2021 SMP Package V (Hilary Rd, Delaware, Whitefield) Project
Solicitation Number: CO-00359
Job No.: 20-5012 & 20-5511

ADDENDUM 1
August 25, 2020

SAWS 2021 SMP PKG V
SEWER IMPROVEMENTS
INDEX AND QUANTITY SUMMARY SHEET

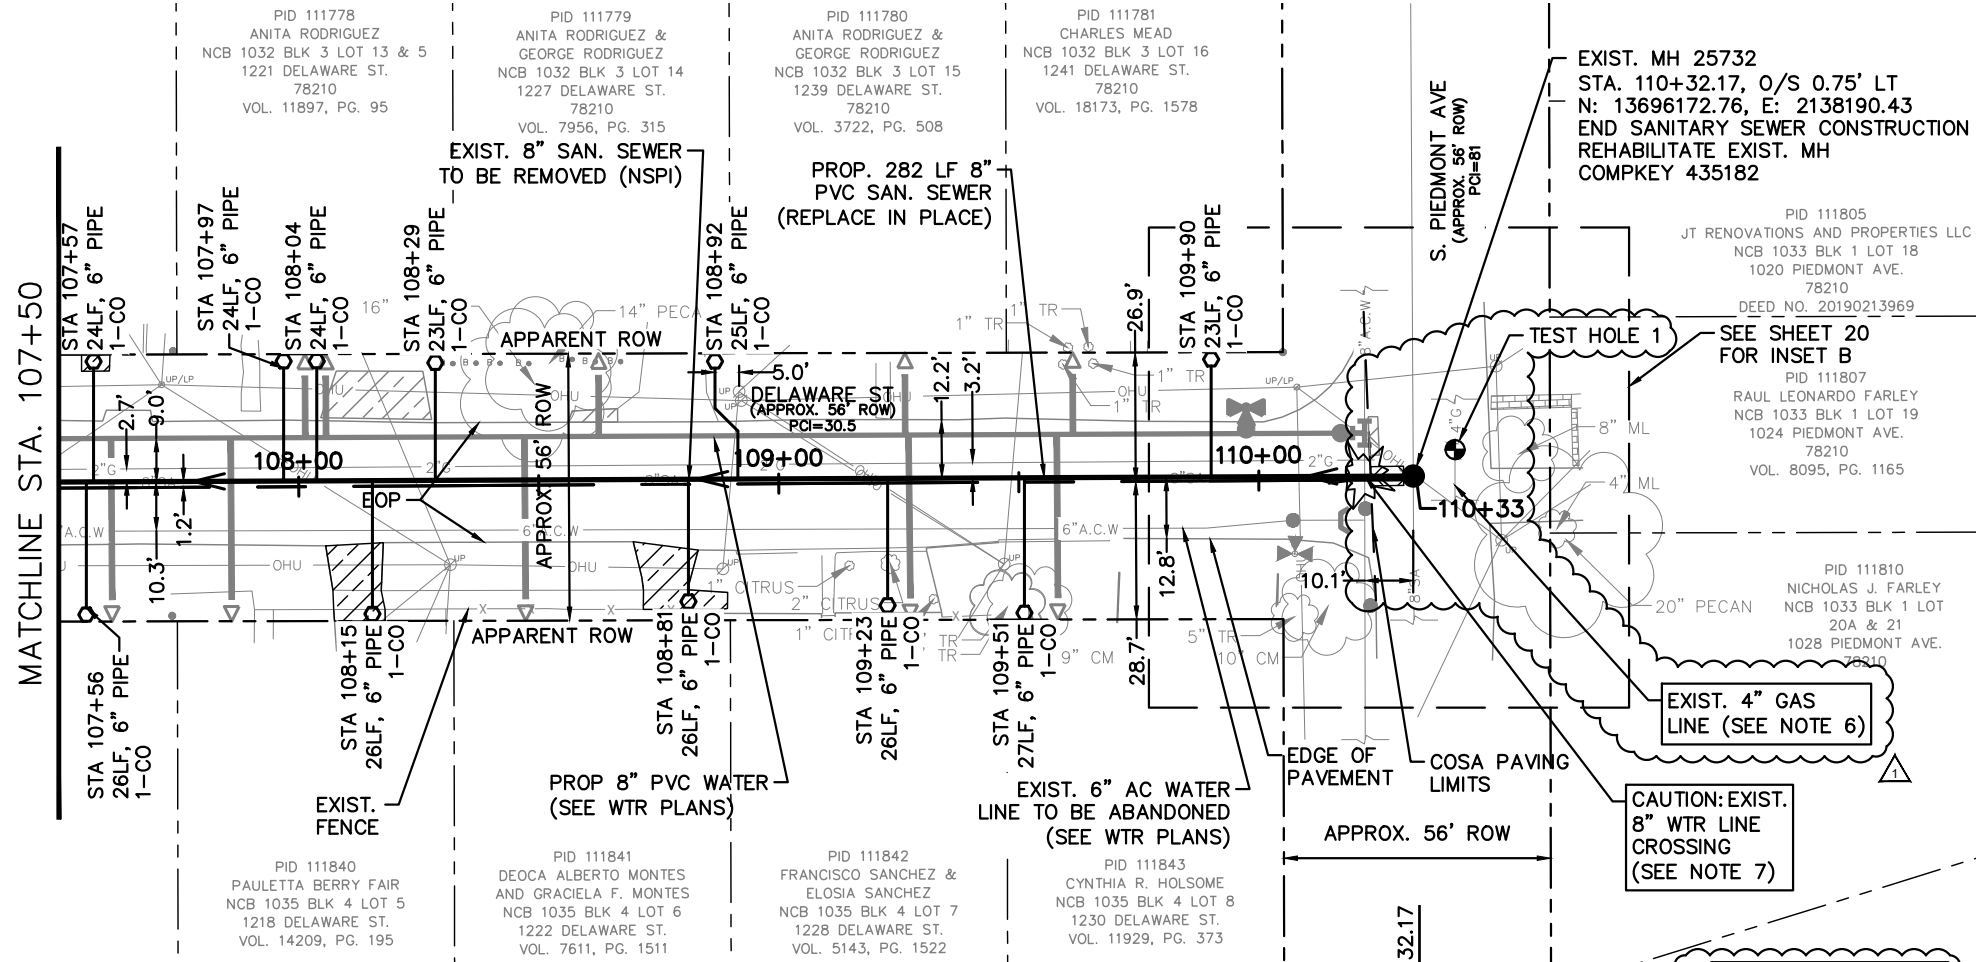
- Added Item 849 and revised quantity to Item 413.2 on Sheet 2 of the Sewer Improvements.
- Revised Sheets 13 and 15 to the water improvements and Sheets 17 and 19 to the sewer improvements to include existing trees surveyed within the right-of-way of Whitefield Ave.

SAWS 2021 SMP PKG V
 SEWER IMPROVEMENTS
 DELAWARE ST STA 107+50 TO STA POE

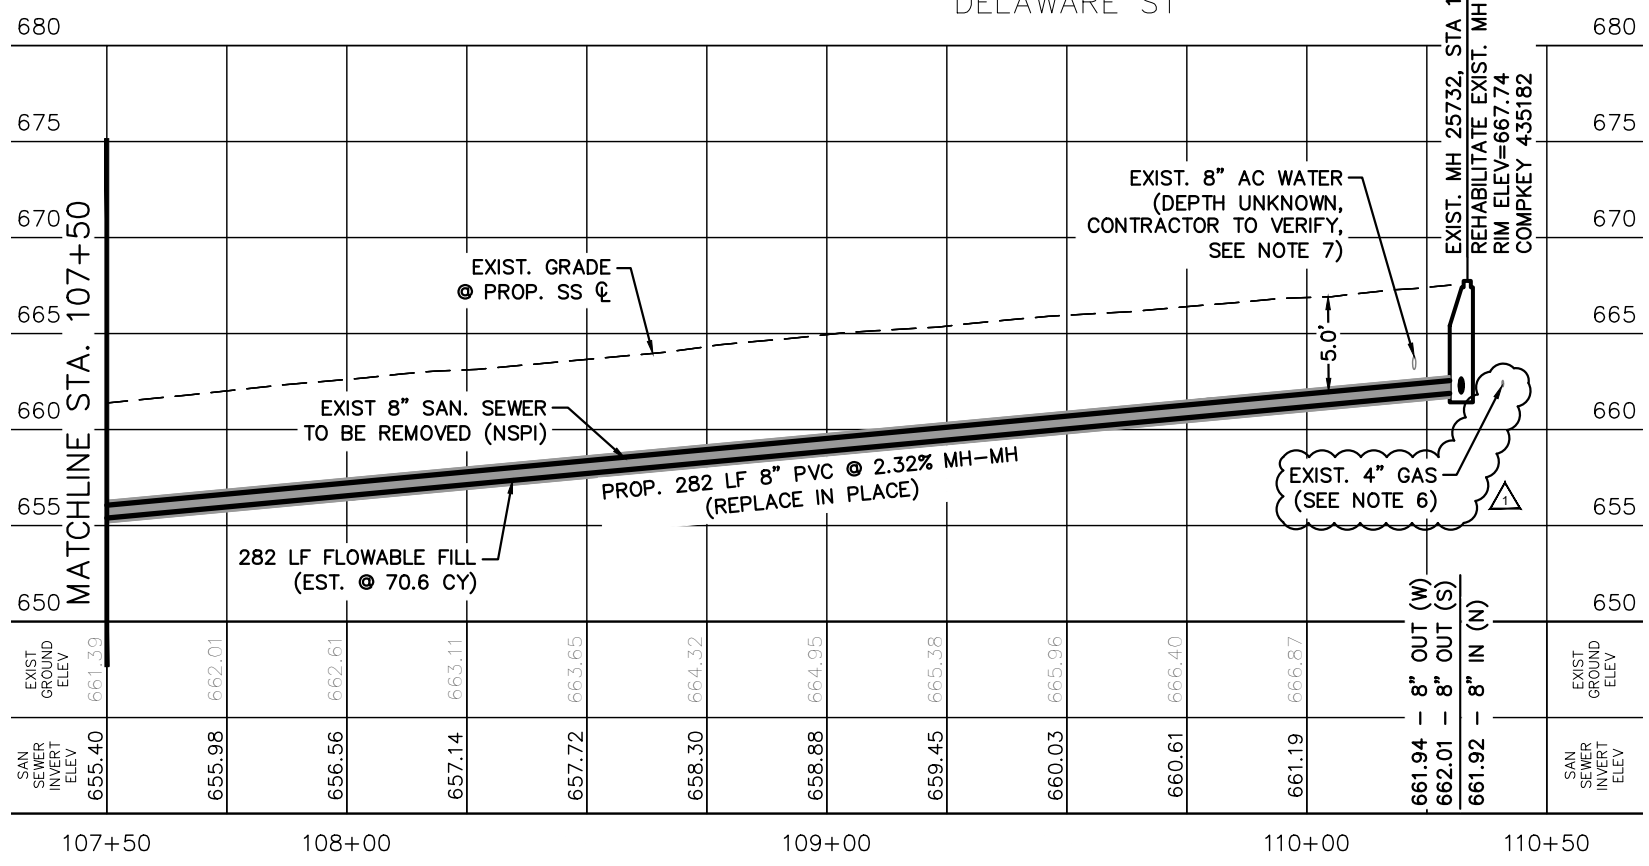
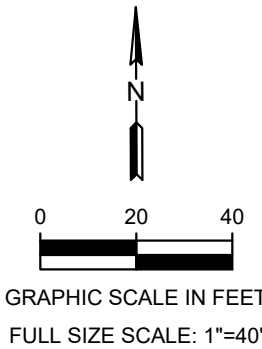
- Test hole (#01) conducted at Delaware St. and S. Piedmont Ave. Summary of Test Hole Information and Coordinates may be found attached to this addendum with the respective plan sheets revised (Sheet 12 and 16-Water Improvements, and Sheet 14 and 20-Sewer Improvements).

TEST HOLE 1
 4" STL GAS
 N: 13696178.24
 E: 2138199.14
 GROUND ELEV = 668.10
 DEPTH = 5.54
 OWNER: CPS ENERGY
